# Access Compliance Report

## Public Rights-of-Way

Intersection ID: 4344	Main Street: MALLARD_GROVE_RD	Cross Street: POCHARD_CT	Location: SW
ADA ID: 4CF6FCF73930	Ramp Type: BlendTrans1	Initial Pass/Fail: Fail	Overall Compliance: No
		Severity Score: 10

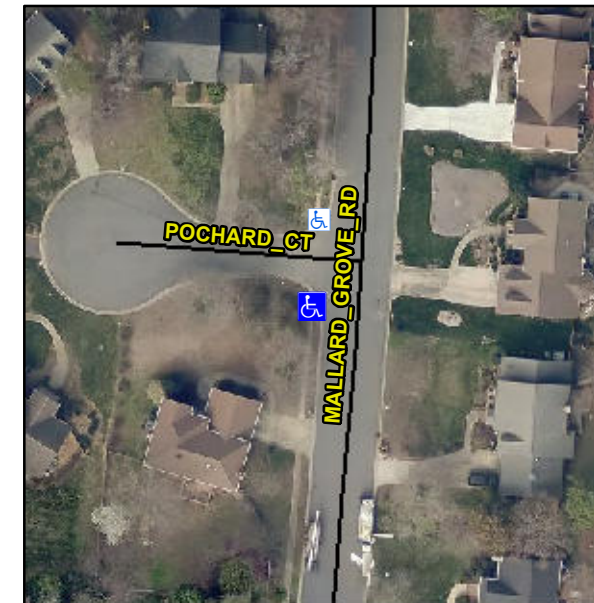
**R304.5.1, R304.5.3**

Compliance	Description	Data	Compliance	Description	Data
N/A	Ramp Length (in)	62.0	Yes	BlendTrans Slope (%)	2.1
No	Ramp Width (in)	45.0	No	BlendTrans XSlope (%)	3.1
N/A	Flare Type LT	N/A	N/A	Flare Type RT	N/A
N/A	Flare Slope LT (%)	N/A	N/A	Flare Slope RT (%)	N/A
N/A	Flare Traversable LT?	N/A	N/A	Flare Traversable RT?	N/A
N/A	Landing Length (in)	N/A	N/A	DWS Provided?	N/A
N/A	Landing Width (in)	N/A	N/A	DWS Contrast?	N/A
N/A	Landing Slope (%)	N/A	N/A	DWS Length (in)	N/A
N/A	Landing X Slope (%)	N/A	N/A	DWS Full Width?	N/A
N/A	Landing Curb? (Y/N)	N/A	N/A	DWS Offset (in)	N/A
N/A	Shared Landing?	N/A			
N/A	Gutter Ponding?	N/A	N/A	Gutter Slope (%)	N/A
N/A	Gutter Lip Ht (in)	N/A	N/A	Gutter X Slope (%)	N/A
N/A	Painted X Walk1?	No	N/A	Painted X Walk2?	N/A
	X Walk 1 Direction	To N		X Walk 2 Direction	N/A
	X Walk 1 Width (in)	N/A		X Walk 2 Width (in)	N/A
	X Walk 1 Slope (%)	5.2		X Walk 2 Slope (%)	N/A
	X Walk 1 X Slope (%)	1.0		X Walk 2 X Slope (%)	N/A

N/A	Ramp inside XWalk1?	N/A	N/A	Ramp inside XWalk2?	N/A
	Road Slope (%)	1.0		Clear Space?	N/A
	Road X Slope (%)	5.2	N/A	Clear Space to XWalk (in)	N/A
N/A	Any Obstructions?	N/A	N/A	Storm Grate/Utility Hazard?	N/A
	Obstruction Type			Storm Grate/Utility Type	
		N/A			N/A
			Yes	Surface Condition? (G/P)	Good
			N/A	Curb Slope (%)	2.8

**Remove & Replace Curb Ramp With Two New Directional Ramps or Equivalent.**
